Response to Submissions – Further Information re Heritage Impact

Alterations to the Australian Habitat and construction of a Wildlife Retreat are proposed at Taronga Zoo. Approval has been sought and the DA exhibited as SSD 7419. The Department's review of submissions received indicated that further information and assessment was required about heritage. Additional information was requested in a letter dated 2nd June 2016 from the Department of Planning namely:

The following additional information has been prepared by Jean Rice, TSCA Senior Project Manager Heritage and refers to additional drawings prepared by Cox Associates and Green and Dale.

3.3 Guest Lodge & Platypus Pools

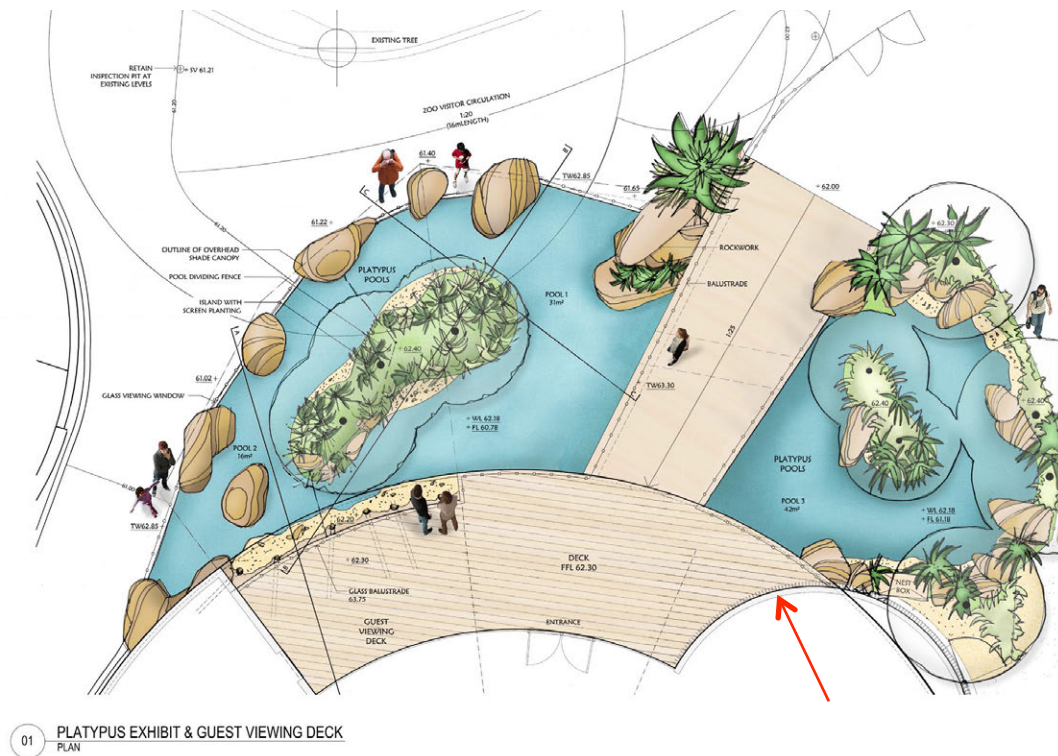
Detailed plans and perspective drawings have been developed showing in part how the 1917 fountain base will be incorporated into the lodge building. The fountain is proposed to become a reception area and office part with a circular external wall over and part forming the base of an internal counter. The ground levels are to be lowered around the former fountain to about the original levels exposing the side of the fountain to view. The adjacent entry to the building is to be via a “bridge” over platypus ponds, which will be at a lower level, to an entry deck. The interface of the deck and ponds with the fountain base is a matter for detailed design. The landscape concept shows a nesting box in front of the fountain base but this is a matter for detailed design. The perspective drawings following show the concept but the ground levels have not been reduced in the drawing though this is what is intended.

The location of the fountain base in the landscape concept plan (extracted from the EIS) above is arrowed.

The detailed drawing, following, shows the proposed changes to the fountain base. The masonry fountain base is generally to remain and the existing masonry wall above in part (the extent is a matter for detailed design). The new curved external wall is above the fountain base and is designed to read as a separate element distinct from the fountain base but reflecting its form. The interior floor will be approximately at the level of the existing base of the fountain, which is now buried below the existing kiosk floor slab. The curved edge of the interior of the former fountain at the junction of the floor and wall is to be retained. The hexagonal base in the centre of the fountain may be able to be retained in part as the base of the proposed fish tank but this cannot be determined until the structure is exposed after the demolition of the modern concrete floor and kiosk over.

2 PROPOSED PLAN
 100928_001 SCALE 1:50

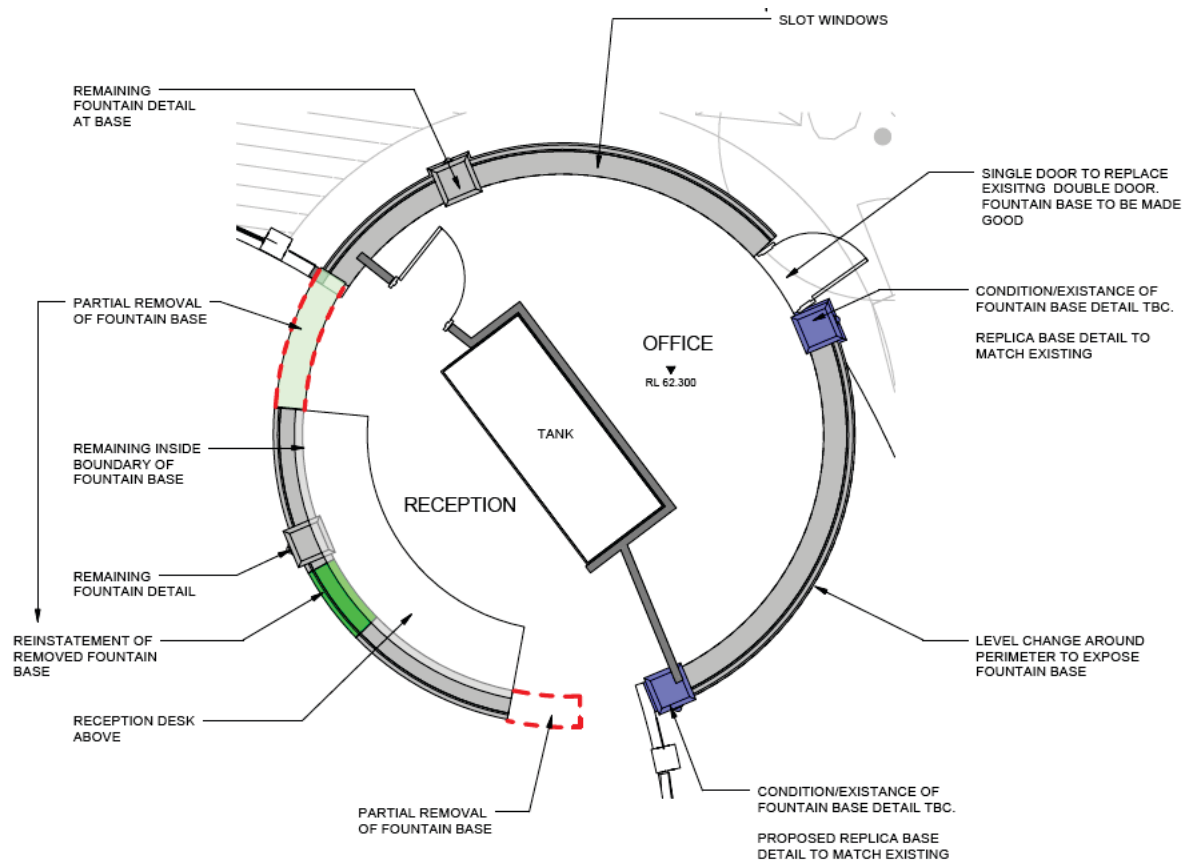
The plan shows the existing fountain base and where openings have previously been made in the base. The two missing piers are proposed to be reinstated. The northeast existing door is proposed to be reduced to a single door enabling the missing pier to be reinstated. The south double door will be removed allowing the adjacent pier to be reinstated and a section of original fountain edge on the other side of the opening is to be removed to create access into the room. The existing opening to the southwest is proposed to be infilled to match. A new opening is proposed to the northwest to allow access to the space behind the counter.

The perspective drawing shows an interior view of the entry looking towards the former fountain. The portion facing the interior is proposed to be a counter. The modern wall now above the fountain base will be retained to the height of the underside of the counter. Fixings will be into that wall meaning fixings will not be required into the fountain base. The detail of the external wall has not been determined. The fish tank behind the counter is a reference to the former fountain – also a fishpond.

The plan shows the existing fountain base and where openings have been made in the base. The perspective drawing shows an interior view of the entry looking towards the former fountain. Source: Prepared by Cox Associates for additional information 2016.

Circular Kiosk

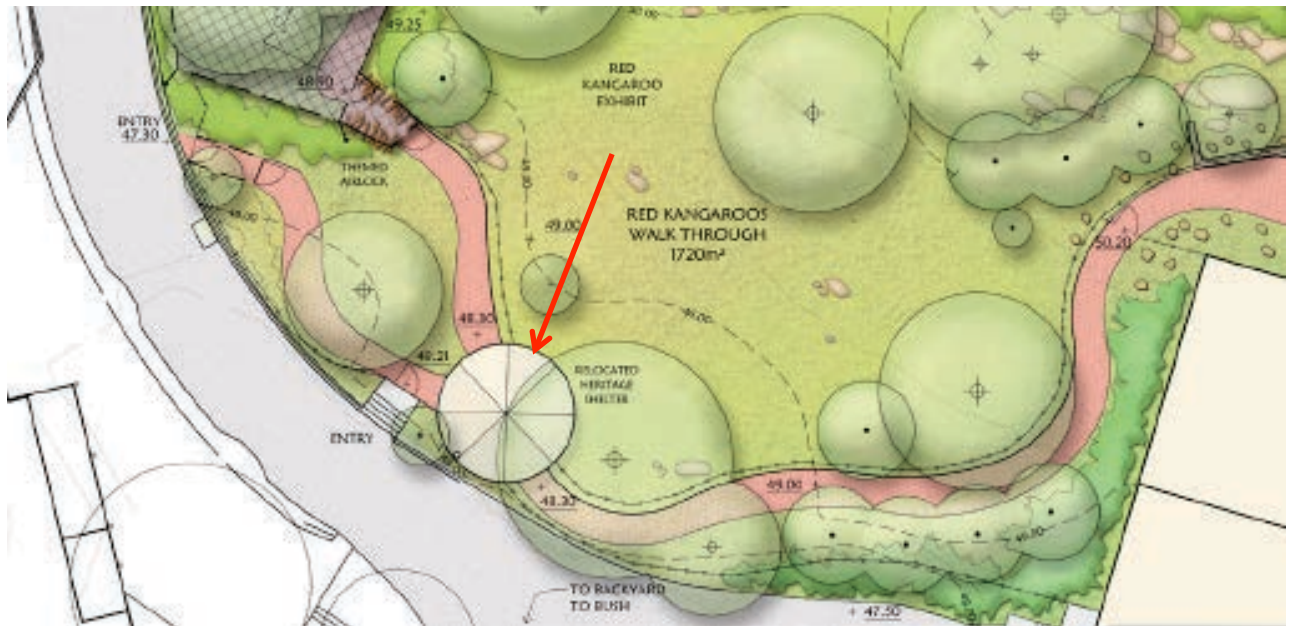
Development of construction details to relocate the kiosk / shelter will be undertaken as part of the detailed project design. This will require considerable further detailed, invasive investigation of the existing heritage structure that is inappropriate to do without DA approval. Archeological assessment of the proposed new site will also inform the detailed design and this cannot proceed until relevant approvals are obtained. The detailed architectural drawings for the relocated structure will include the concrete floor slab, circular masonry wall and connections to columns as well as the seating and openings in relation to the new paths and columns. The new location of the building will be on the Wollemi lawn and is shown on the landscape concept drawing (arrowed in extract below).

The structure will be rebuilt to match its former configuration as a shelter shed, using the evidence of historic photos (following) and careful assessment of the existing structure as it is being 'un-built' when original construction details may be revealed. Subject to engineering advice the roof will be removed as one element and craned to a temporary platform near its new location. At the new site a new circular concrete slab floor will be built with a footing for the central column which will match the existing hexagonal column. The walls will be masonry, either rendered brick or concrete, painted. The wall will be circular with openings at the paths designed to be between columns.

4.0 Heritage – Original and Early Paths

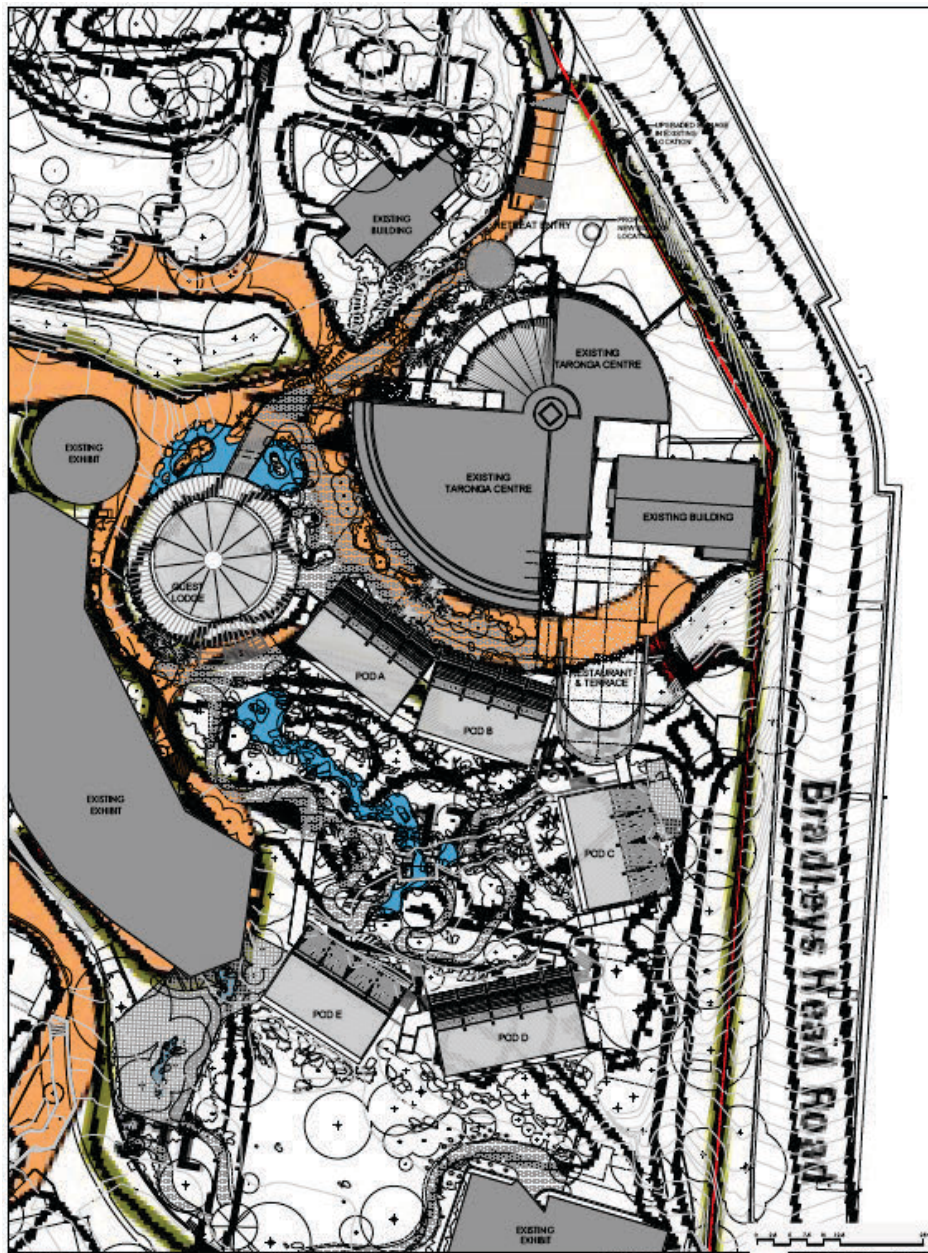
- *Provide a diagram showing the alignment of the Original and Early Paths (item 99L) overlaid on the project's architectural and landscape plans;*
- *Provide item specific mitigation measures for impacts on the Original and Early Paths; provide item specific mitigation measures for the partial removal of the Rustic Stone Garden Walling (item 149L);*

The diagram following shows the alignment of the Original and Early Paths (item 99L) from the CMS overlaid on the project's architectural plan. The dark lines are from the CMS drawing, which is at a smaller scale and does not have a high level of accuracy. Refer to Heritage Impact Statement.

The map of the original and early paths in the CMS is on a diagrammatic map and indicates the approximate extent. The extent differs in detail as the paths on the diagram are the “current” paths, which have in some cases changed from the original. The Heritage Impact Statement explains the development of the paths in this area and the detail of what has been altered at different times. Within the site all of the early paths have been resurfaced and levels changed but some alignments remain the most intact being at the top of the site (near spider monkeys) however the former steps have been removed and levels and alignment of one side changed. At the bottom of the site between the Wollemi Lawns and Elephant enclosure the path is at similar levels and alignment but the alignment on the west side is altered and the road crossing what is now the lawn has been removed. The original and early paths in the area of the project have been indicated following on an overlay of the 1975 survey and the current survey as well as on an overlay of the current survey and the architectural plans. The coloured paths indicate the areas where the alignment in part remains or is proposed to remain.

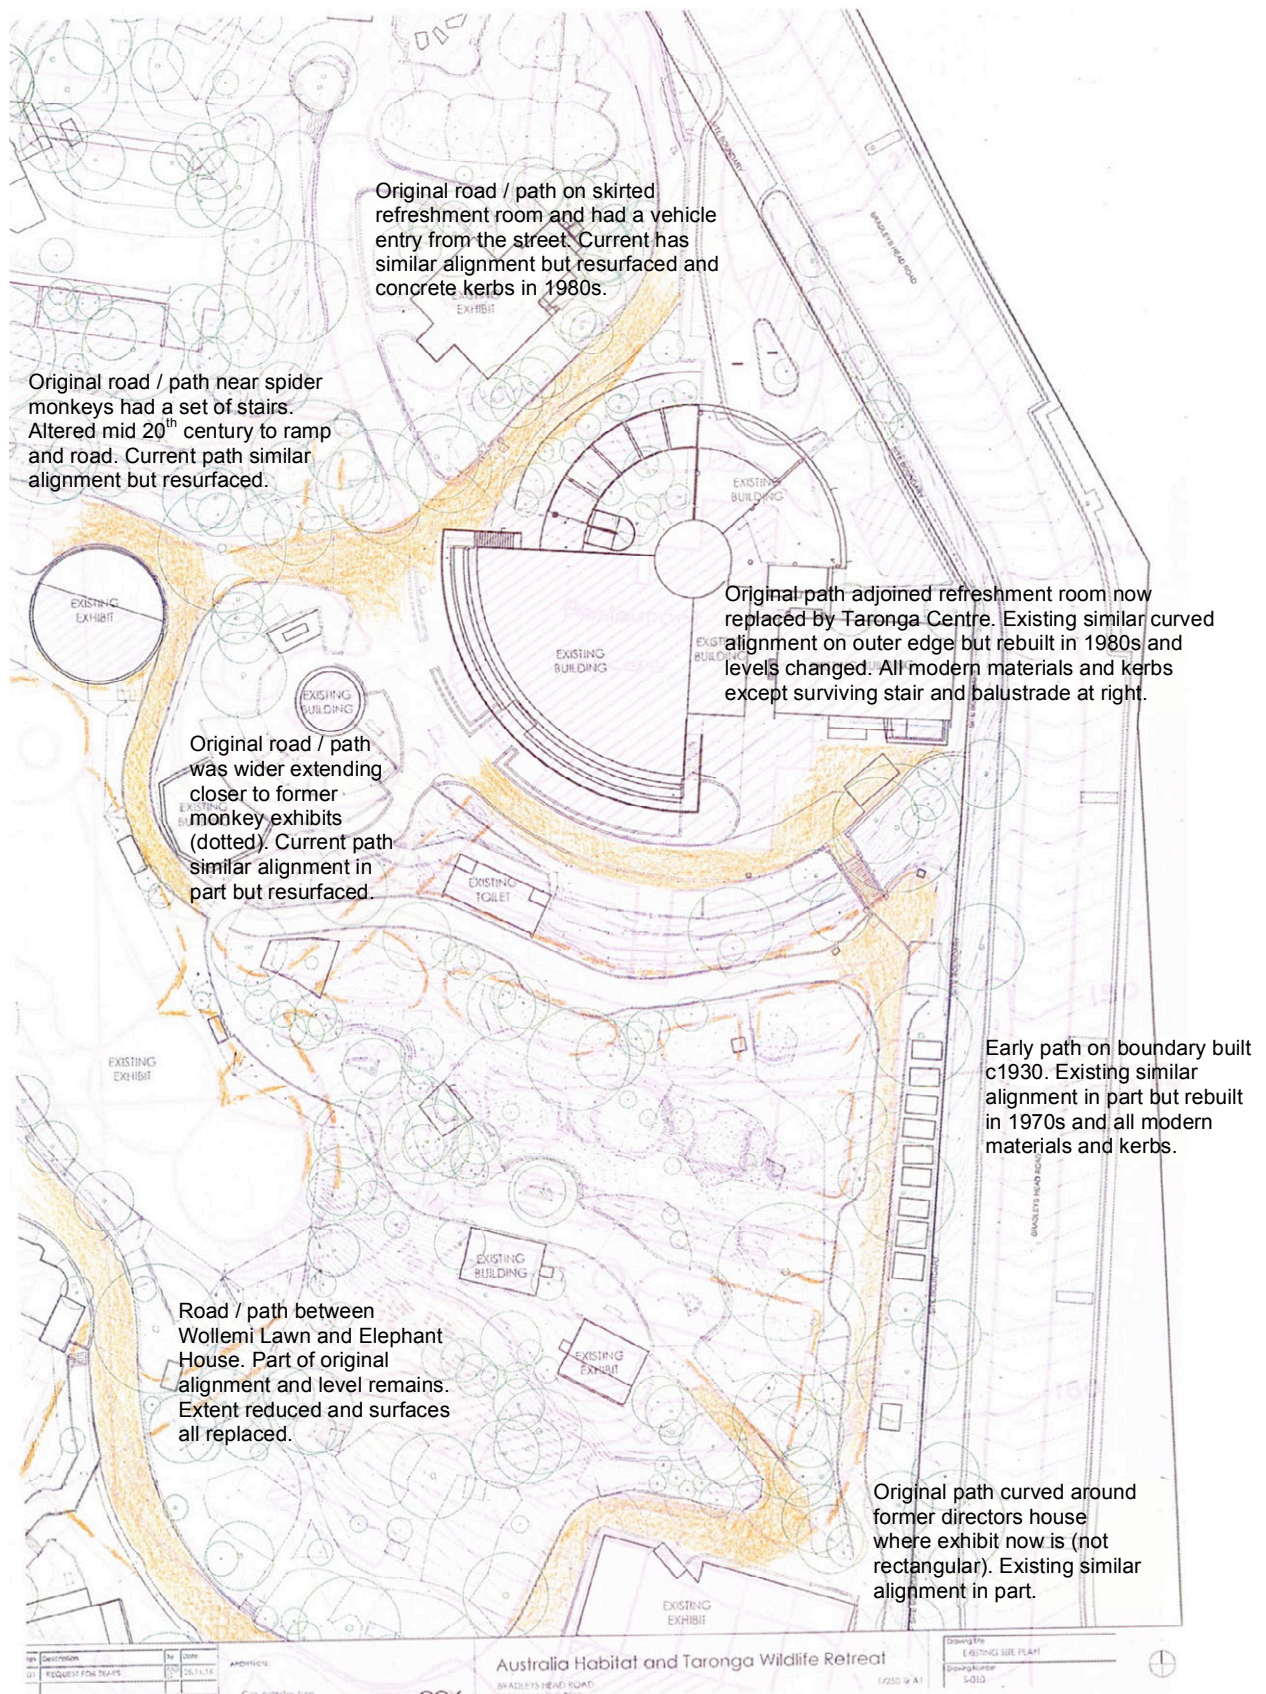
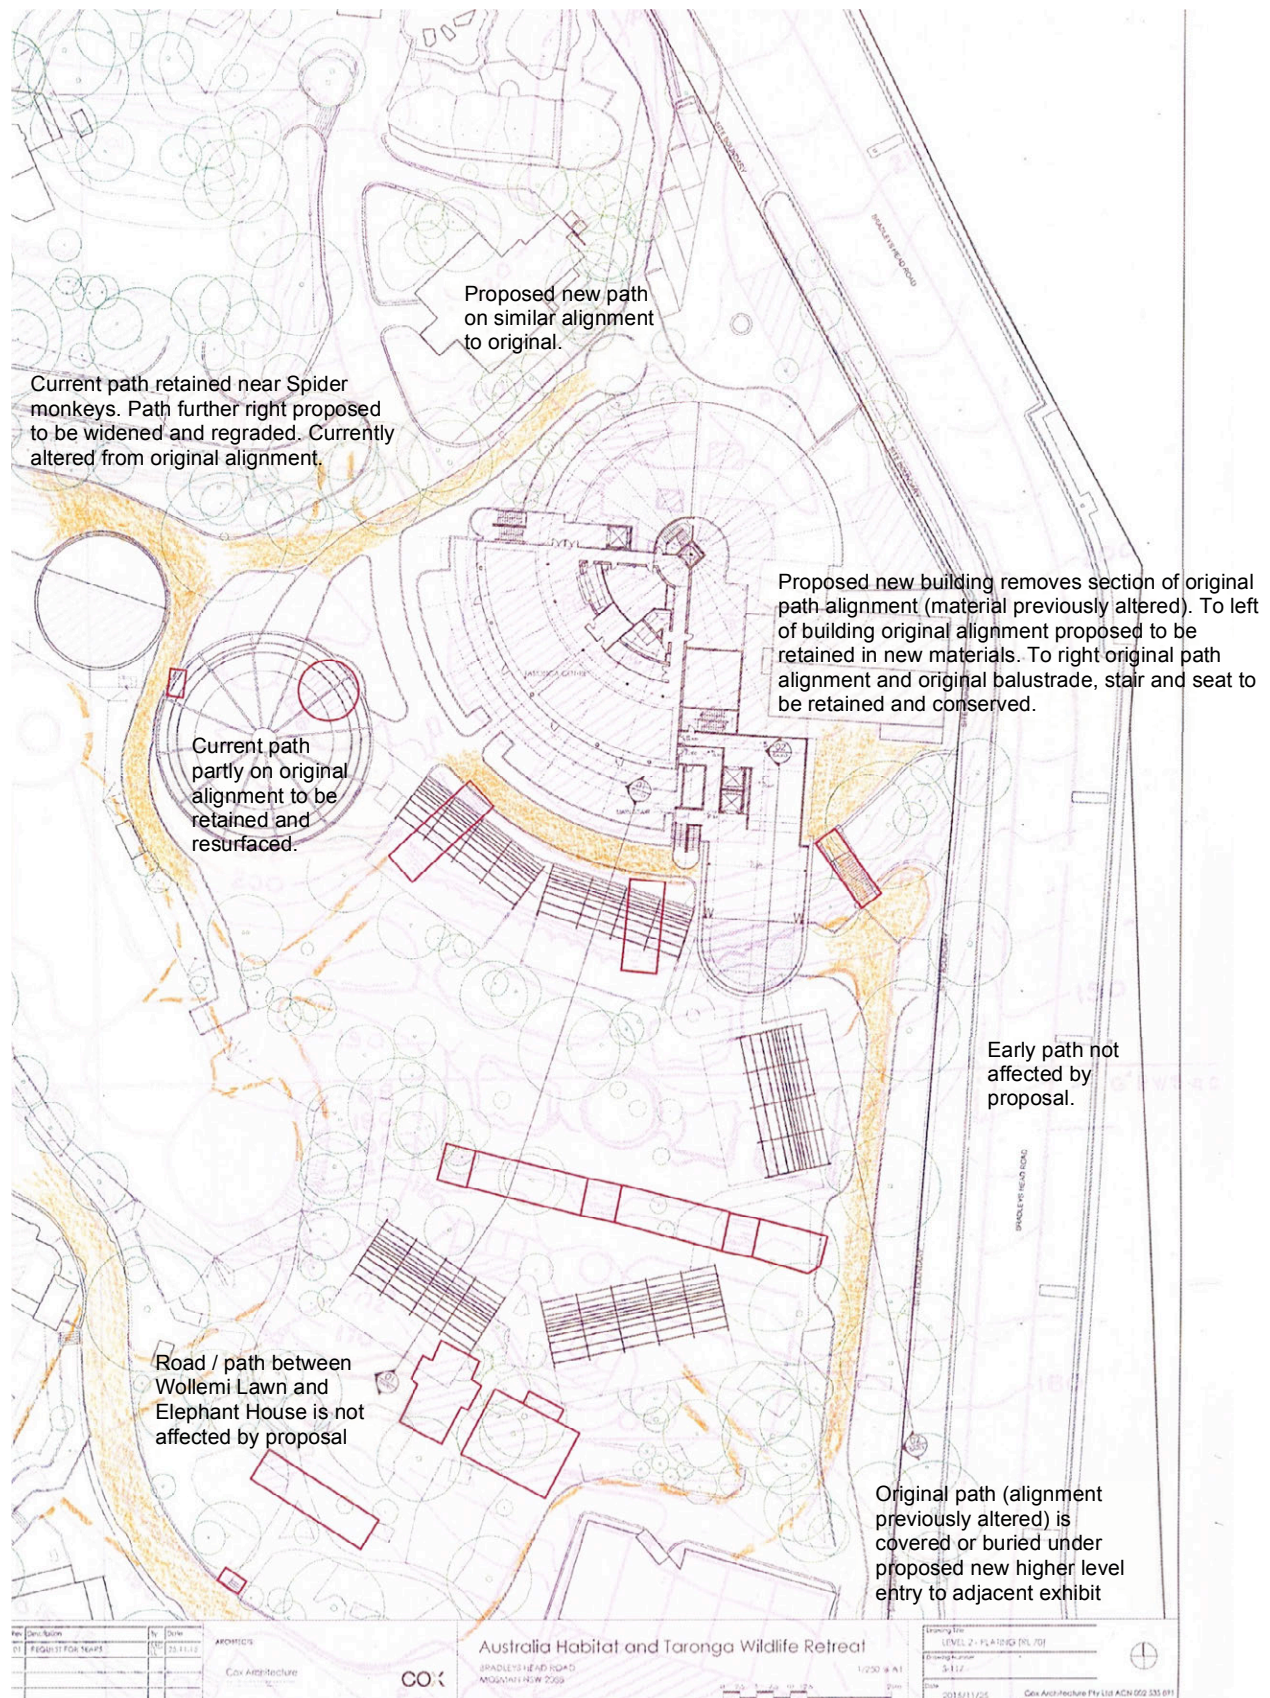
The 1975 survey is the purple lines showing the earliest detailed map available. The black lines are the 2015 survey. The coloured areas are where elements of the original or early path layout or alignment remains in part. Dotted lines indicate former extent of original or early paths near what remains.

The 1975 survey is the purple lines showing the earliest detailed map available. The black lines are the proposal. The coloured areas are where elements of the original or early path layout or alignment is proposed to remain as is. Dotted lines indicate former extent of original or early paths.
